UPPER VENTURA RIVER GROUNDWATER AGENCY

UPPER VENTURA RIVER GROUNDWATER AGENCY BOARD OF DIRECTORS
REGULAR MEETING AGENDA

SUBJECT: Draft Groundwater Sustainability Plan Comments (Grant Category (e); Task 12: GSP Reviews and Approvals)

Subject: Comments on the Upper Ventura River Groundwater Agency Draft Groundwater Sustainability Plan

Figure ES-08: Groundwater Elevation Contours and Flow Directions

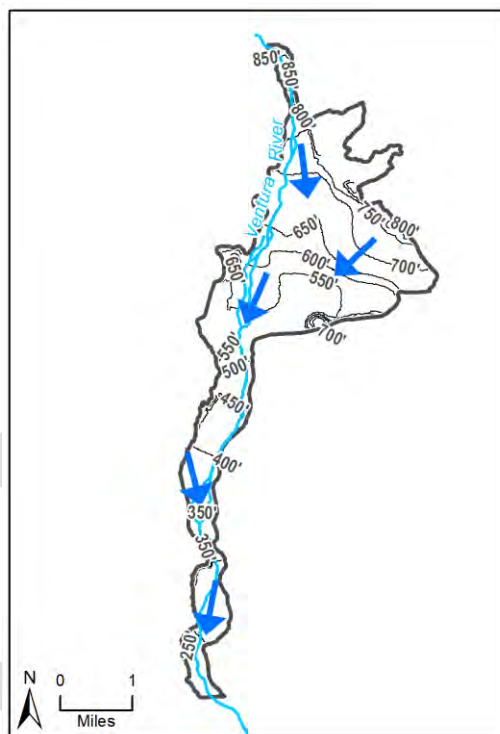
Possibly from Monterey formation as well?

Maps of representative monitoring sites in relation to key beneficial users

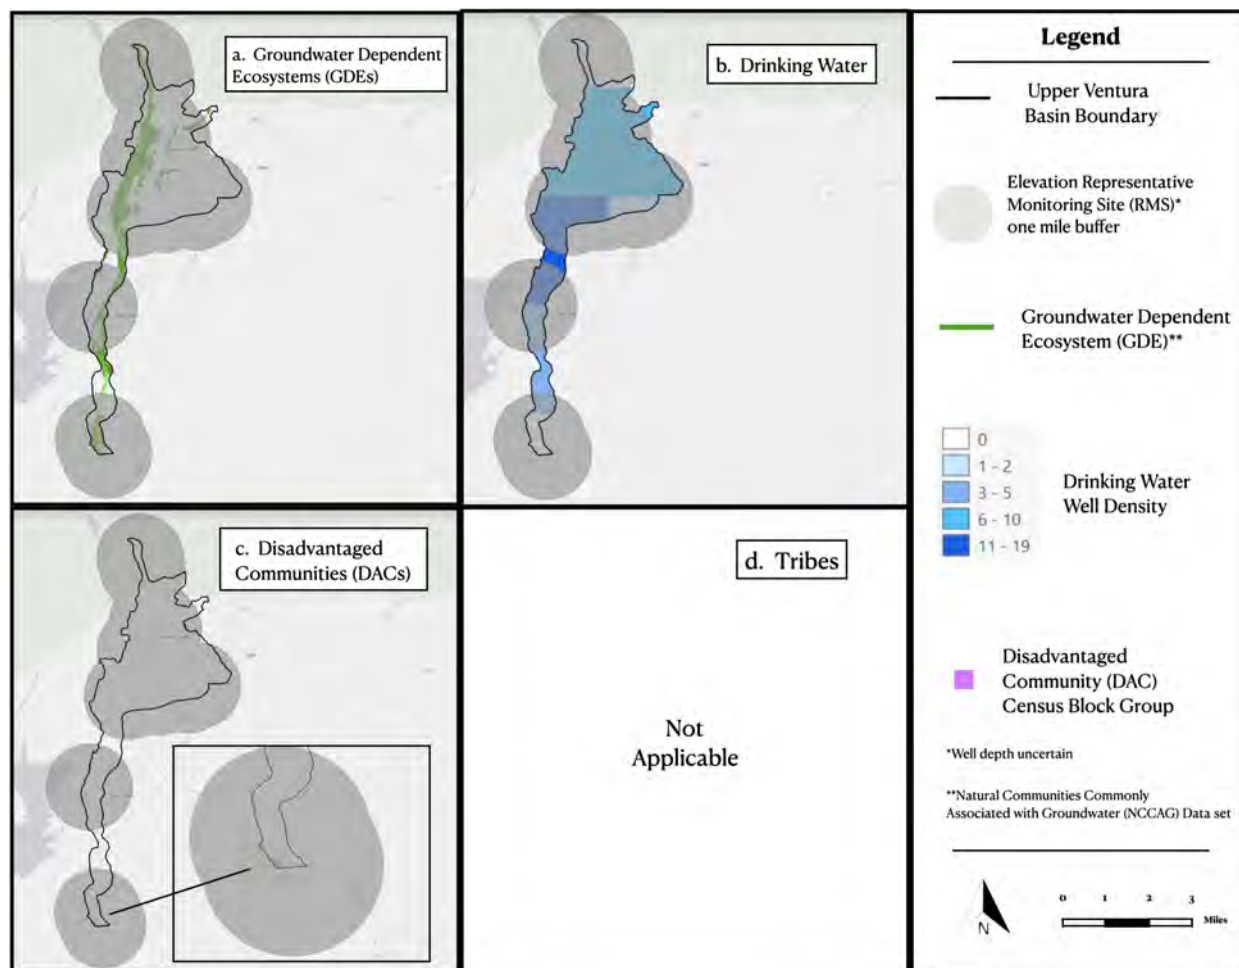
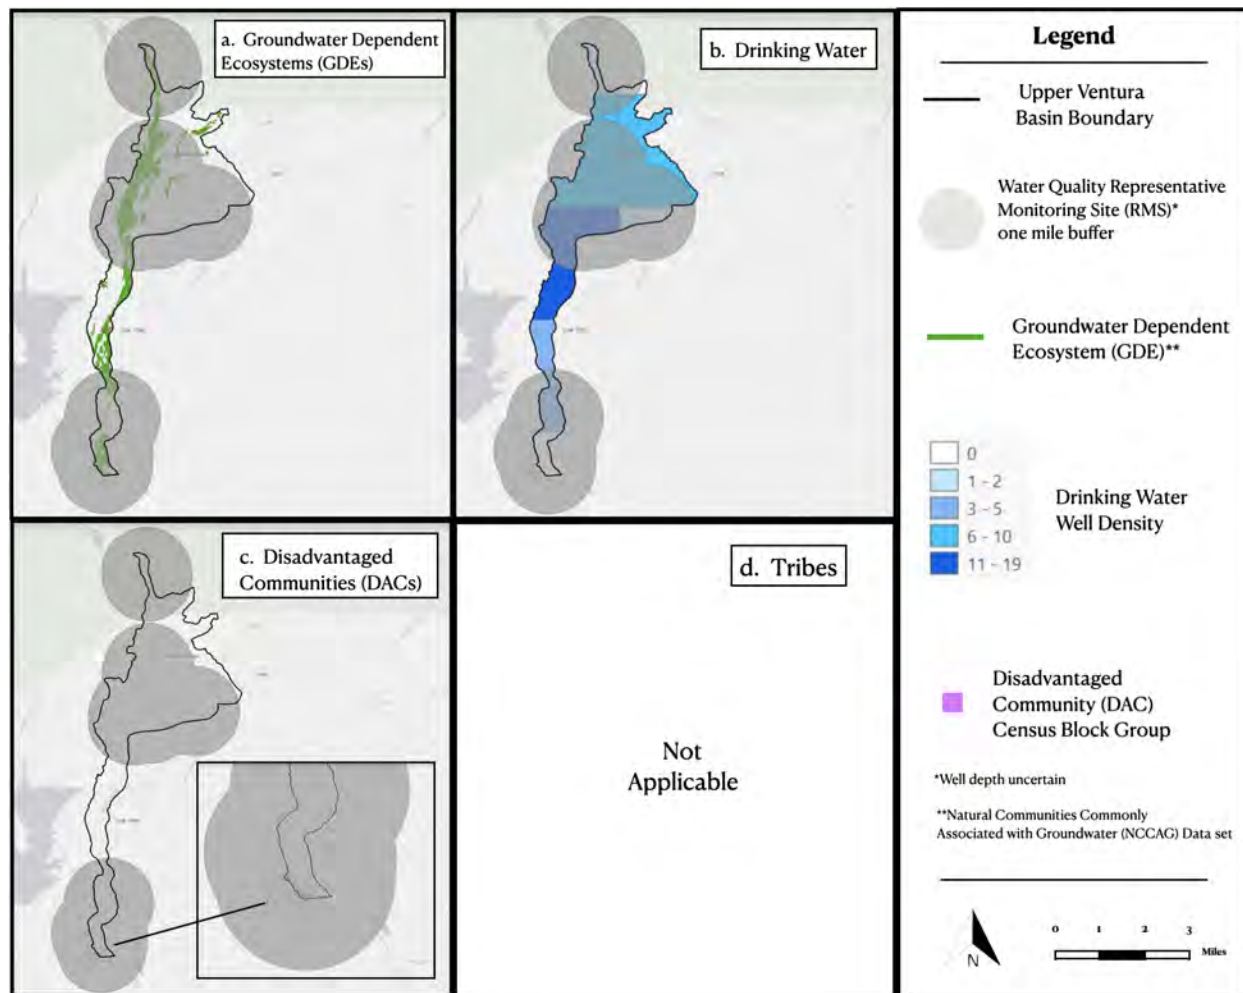
Figure 5.6-01 (Existing and Planned Water Quality Monitoring Network) shows that no monitoring wells are located across portions of the basin near DACs and domestic wells (see maps provided in Attachment E). Beneficial users of groundwater may remain unprotected by the GSP without adequate monitoring and identification of data gaps in the shallow aquifer. The Plan therefore fails to meet SGMA’s requirements for the monitoring network¹¹.

Figure 2 from Riparian Groundwater Dependent Ecosystems Assessment

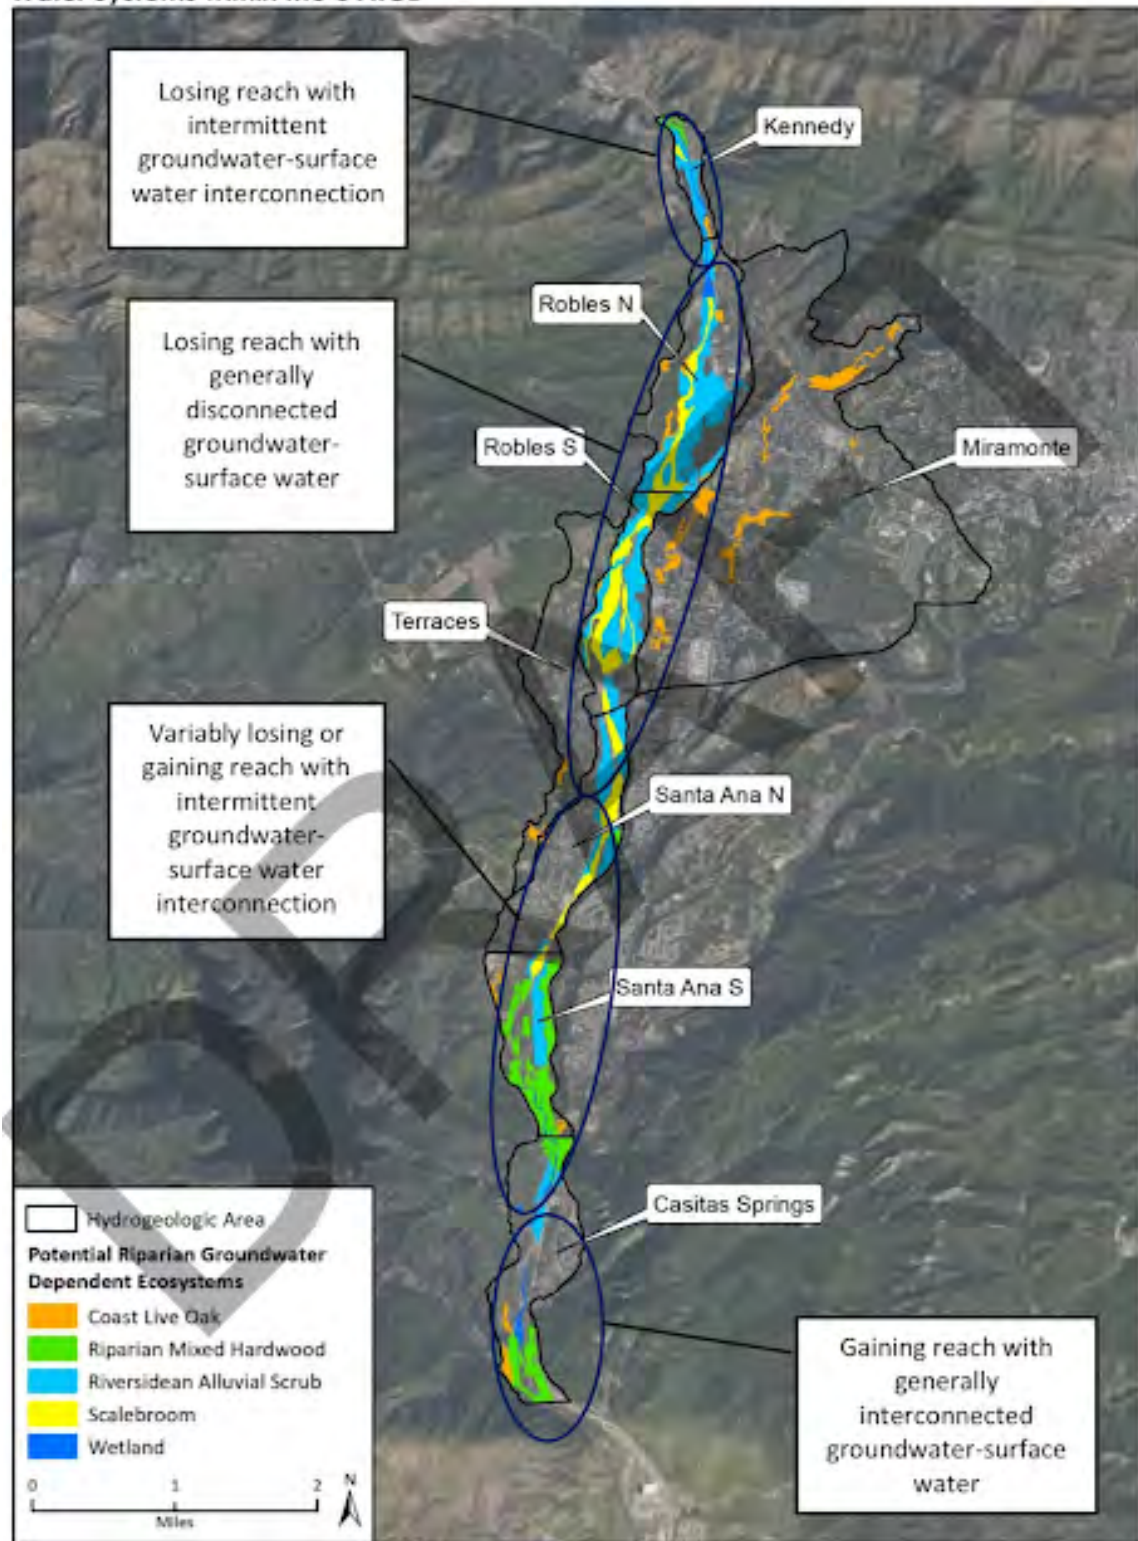
The **Riparian Groundwater Dependent Ecosystems Assessment** Report characterizes the Robles reach as a *“Losing reach with generally disconnected groundwater- surface water.”* This categorization eliminates the majority of this Groundwater Dependent Ecosystem from consideration under SGMA by assuming that it is “disconnected” and thus has too great a depth to groundwater to support riparian habitat. Other reaches are similarly dismissed.

The analysis presented relies heavily on the Nature Conservancy “Natural Communities (NC) Dataset,” using vegetation communities to eliminate GDE polygons from the Upper Ventura River Groundwater Basin. The NC dataset is a statewide geographic computer database that maps vegetation types in all potential GDEs throughout the State of California. The large geographic scope of this map does not accurately represent current on-the-ground conditions, and more robust ground truthing should be undertaken. Even the aerial photos presented tell a different story than is acknowledged in the narrative (i.e. Figure 6 North Robles Habitat Area Photographs, Aquatic GDE Characterization report)

figure from [Model Results and SMC Implications Presentation \(March 25, 2021\)](#)

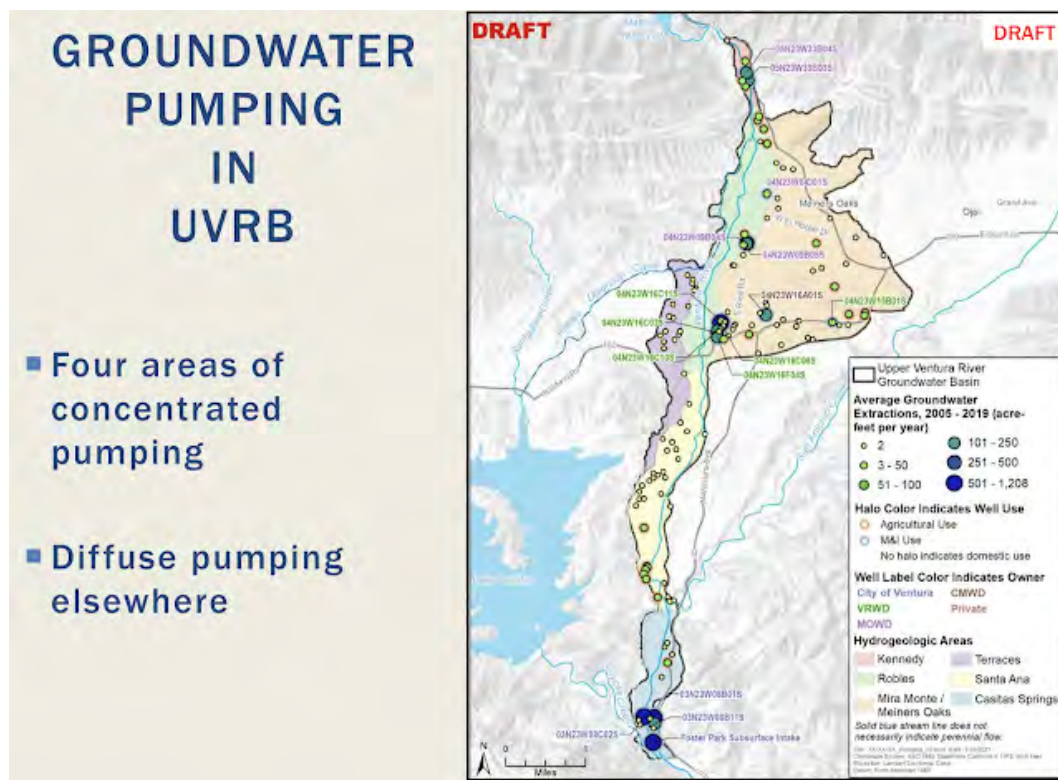
The conclusion that there is no impact from pumping based on the fact that the basin rapidly refills in the wet season points to the likelihood that the surface water is in fact “connected” to groundwater during these periods. Moreover, the fact that pumping represents up to 31% of the basin water budget in critical dry years raises the question of how these groundwater extractions impact surface flows and groundwater levels.

The Model Results identify four areas of concentrated pumping, three of which directly impact groundwater levels in the “Robles Reach.” This reach is the area with the most storage in the basin, and should be considered as the “primary sub-basin” for water supply. The three areas of concentrated pumping in this reach are likely to affect conditions throughout the basin.
